Application for Planning Permission for Proposed Temporary Warehouse for Storage of Construction Materials (Timber and Metal) and Associated Filling of Land for a Period of 3 Years at Lots 123 RP, 124 (Part), 125 (Part), 126 (Part) and 127 (Part) in D.D. 113 and Adjoining Government Land, Ma On Kong, Kam Tin South, Yuen Long, N.T.
(Application No. A/YL-KTS/1147)

Table 1: Responses to Departmental Comments (Application No. A/NE-KTS/1147) (21 September, 2026)

Responses to Comments from Government Departments on Drainage Submission (June 2026) of Planning Application No. A/YL-KTS/1147

PLAN D1

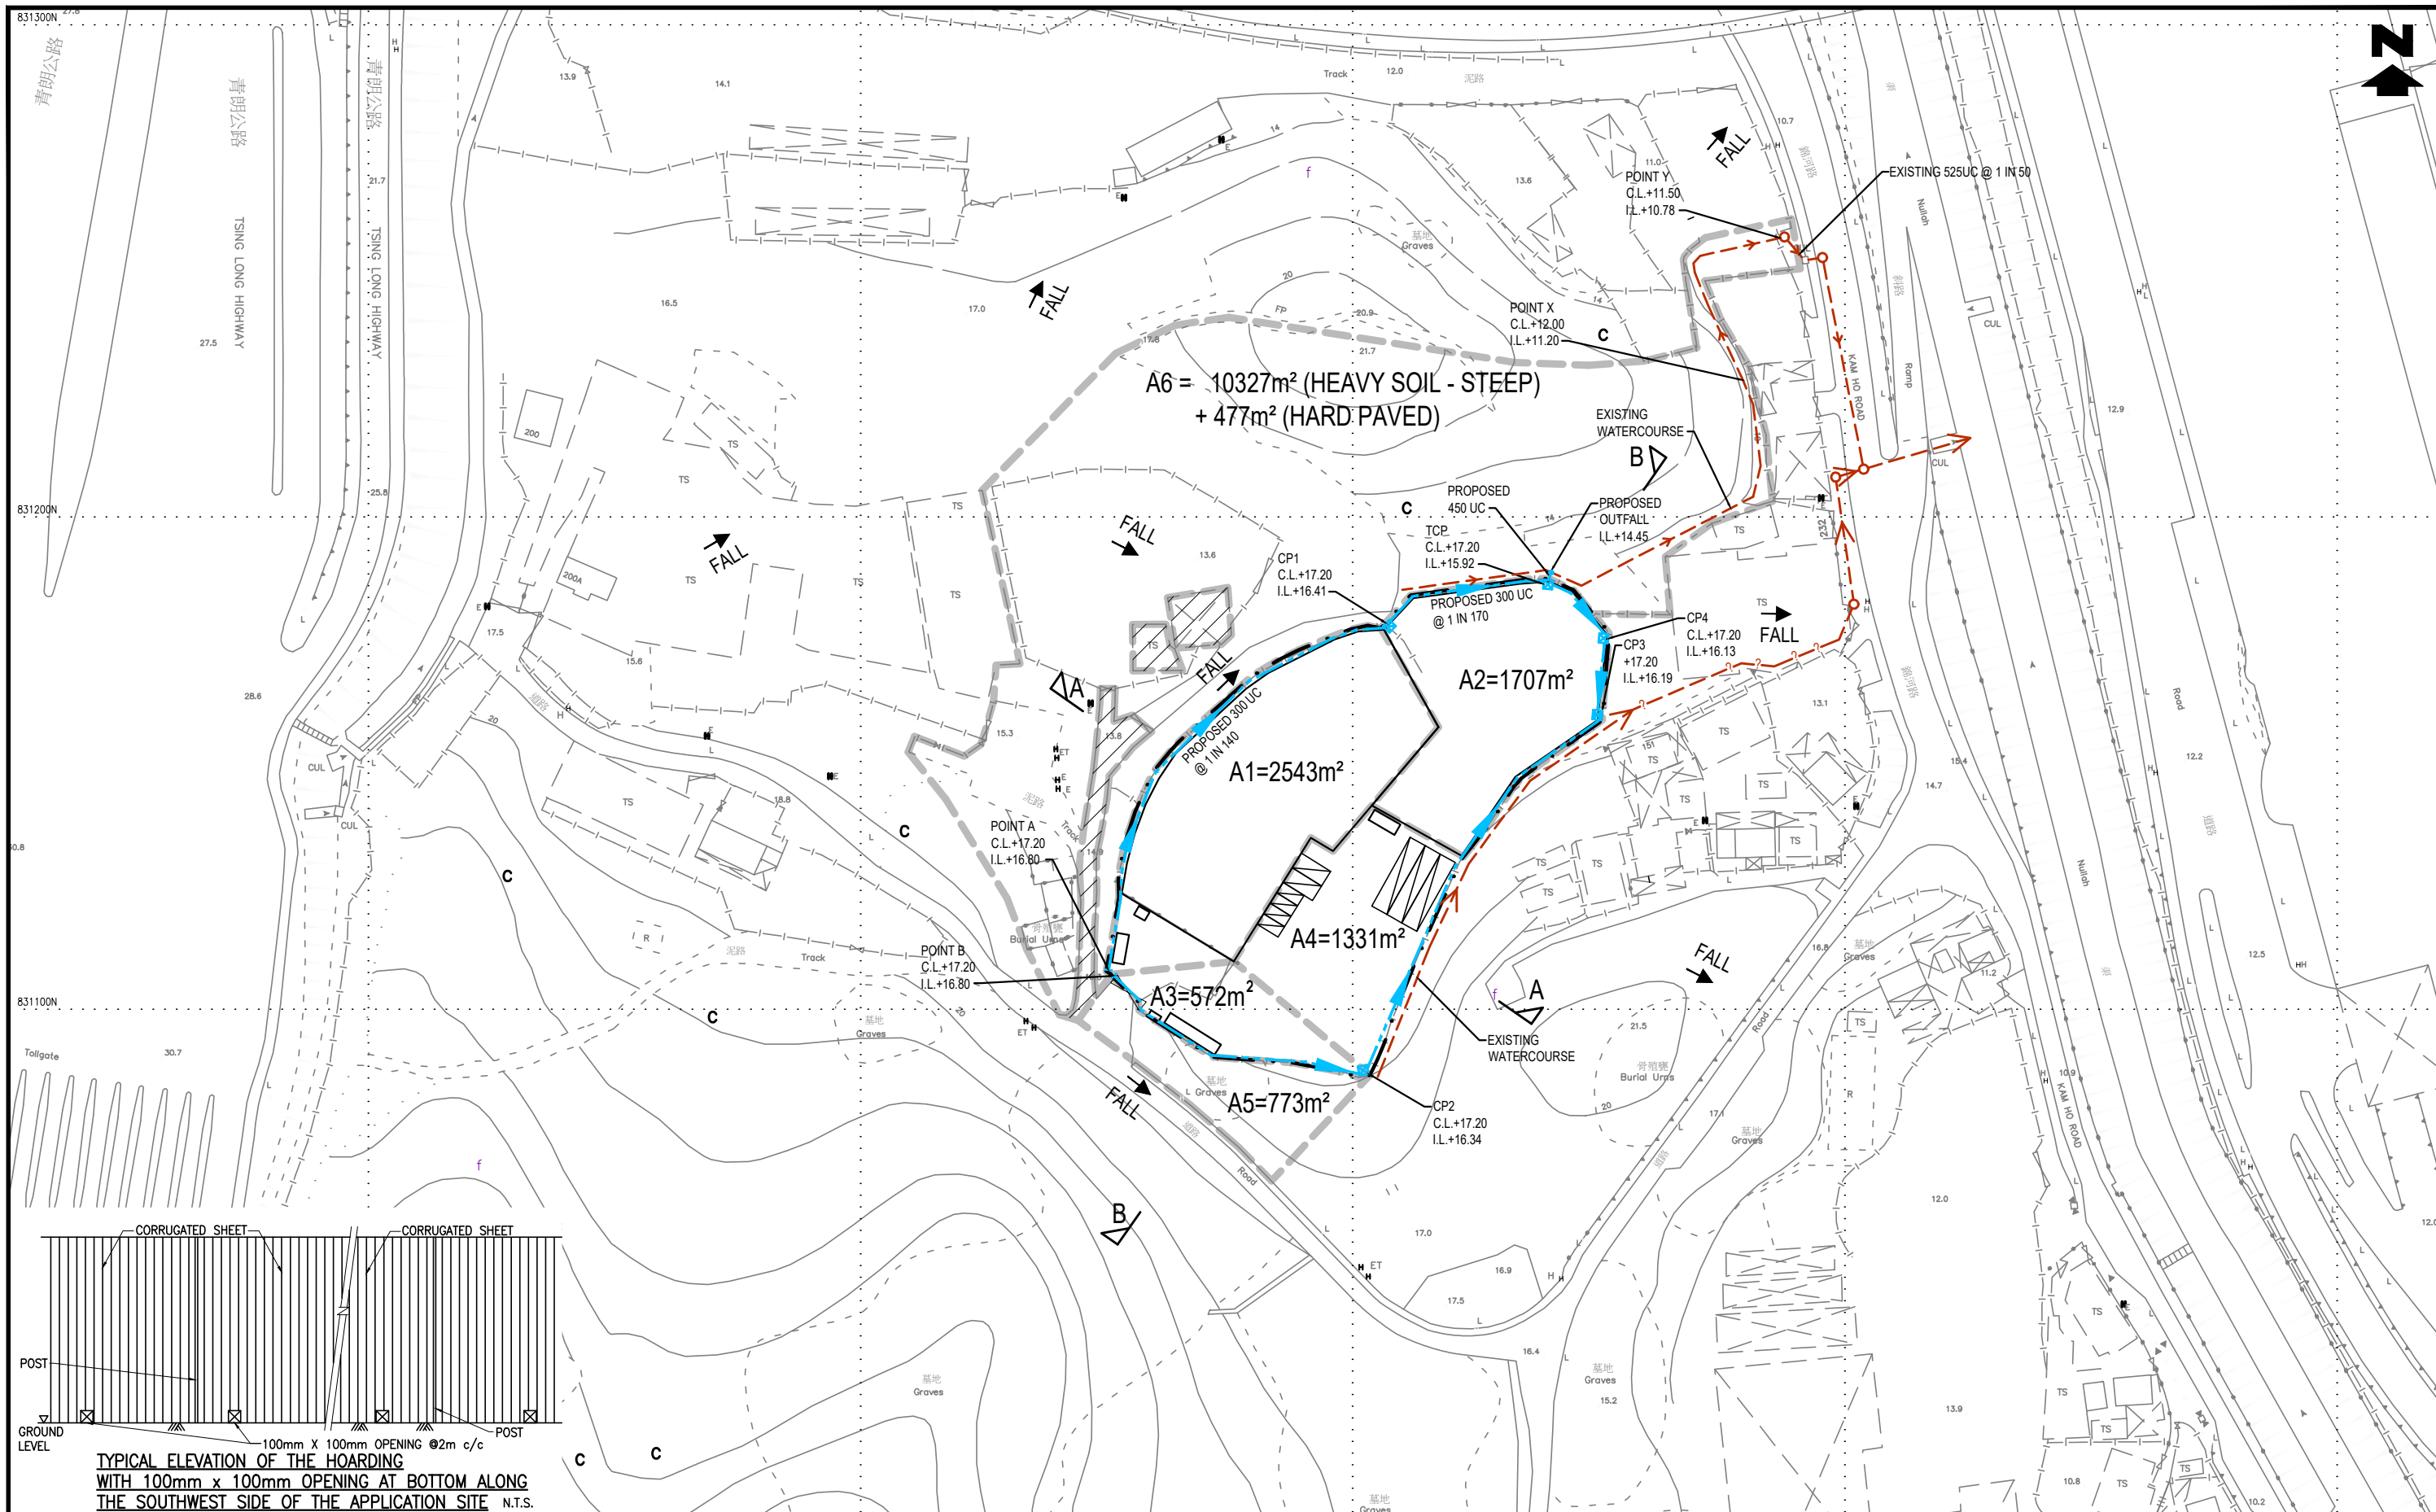
COMMENTS		RESPONSES	
Drainage Services Department (DSD)		Applicant	
(i)	According to the drainage plan (Drawing No. PLAN D2), please indicate clearly the full alignment of the discharge path from the application site all the way down to the ultimate discharge point (e.g. a well-established stream course/public drainage system). According to our recent site inspection, a suspected illegal discharge found from the application site to adjacent lands (near Location 5 of Drawing No. PLAN D1), which caused flooding to adjacent areas. Please ask the applicant to rectify the above and connect to adequate drainage system accordingly.		The full alignment of the discharge path from the application site all the way down to the ultimate discharge point is clearly indicated on PLAN D2 in the submission. Colour photos Nos. 6 to 21 in the submission were taken along the discharge path. The applicant would complete the drainage system as per the Proposed Drainage Management Plan (PLAN D2) including rectification of any drainage irregularities if exist after this application is approved.

(ii)	The ground to the southwest of the application site is significantly higher. Since the overland flow from the adjacent lands shall be probably intercepted, external catchment shall be considered in the calculation. Please make reference to the latest Technical Note No. 1 issued by DSD for more details in preparing the drainage proposal. Please upgrade all drainage facilities size accordingly.		The open area in front of the application site entrance has already been included in the stormwater catchment area of the application site. The ground to the southwest of the application site is significantly higher. However, there is an existing access road running between the higher ground to the southwest and the application site. The levels of the existing access road are relatively lower than the ground levels of the both sides as shown in the following photo:

COMMENTS	RESPONSES
	of flowing onto the application site. The catchment areas of the application site and the flow directions of the adjacent areas are indicated on PLAN D2.
(iii) Please use clear colors/legends showing the proposed and existing drainage facilities on the drainage plan for review.	Noted. Clear colors/legends showing the proposed and existing drainage facilities are adopted on the drainage plan, i.e. PLAN D2.
(iv) Please advise if any site formation/levelling works to be carried out under this application. Cross sections showing the existing and proposed ground levels of the captioned site with respect to the adjacent areas should be given. Peripheral surface channels shall be provided along the site boundary at the existing/original ground level (instead of the revised ground level) to collect the surface runoff accrued on the application site and to intercept the overland flow from the adjacent lands.	The existing levels are the final levels of the application site. No site formation/levelling works would be required/carried out under this application. Cross sections showing the ground levels of the captioned site with respect to the adjacent areas are provided in the updated submission. Peripheral surface channels are to be provided along the site boundary at the existing/original ground level to collect the surface runoff accrued on the application site and to intercept the overland flow from the adjacent lands.

(v) Please confirm if any walls or hoarding are/to be erected or laid along the site boundary. If affirmative, adequate opening should be provided to intercept the existing overland flow passing through the site and please provide its details for comments.	There is hoarding surrounding the application site. However, the ground levels of the application site are relatively higher than those of the surroundings except a small piece of land (about 773m ²) in front of its entrance. In practical, no surface runoff would flow from the surroundings onto the application site except those from the small piece of land in front of its entrance. 100mm x 100mm openings at 2m centre to centre will be formed at the bottom of the hoarding along the southwest side of the application site to allow potential cross-boundary flow of surface runoff from the adjacent areas.
(vi) The applicant should check and ensure the hydraulic capacity of the existing drainage facilities would not be adversely affected by the captioned development. Please also provide site photos at different locations and views to demonstrate the presence and existing condition of the discharge path.	Hydraulic capacity of the existing drainage facilities was checked not adversely affected by the subject development (the calculations are enclosed in the Appendix of the Drainage Submission). Colour photos Nos. 6 to 21 in the submission were taken along the discharge path.

COMMENTS	RESPONSES
(vii) The gradients and the sizes of the proposed/existing U-channels at each section should be shown on the drainage plan for review. Please also indicate the flow direction at each section of the proposed drainage system for reference.	For clarity of the plan, it is stipulated in the 'LEGEND' that 'proposed channels are 300UC at 1 in 200 except otherwise stated'.
(viii) Catchpit should be provided at the turning point of the proposed u-channel.	Noted, agreed and followed.
(ix) Sand trap or provision alike should be provided before the collected runoff is discharged to the public drainage facilities.	A catchpit with trap (according to CEDD Standard Drawing C 2406/1 to /2A – Catchpit with Trap) will be constructed before the collected runoff is discharged to the outside watercourse.

COMMENTS	RESPONSES
	 Surface runoff from the southwest of the application site would hence flow along the access road to the downstream into an existing watercourse running outside the southeast boundary of the application site and the existing watercourse runs directly towards Kam Ho Road direction without crossing the application site. Please refer to the illustration in the following:

COMMENTS	RESPONSES
	  Therefore, all the overland flow from the ground to the southwest of the application site would be intercepted by the existing access road and diverted to the downstream along the existing access road instead
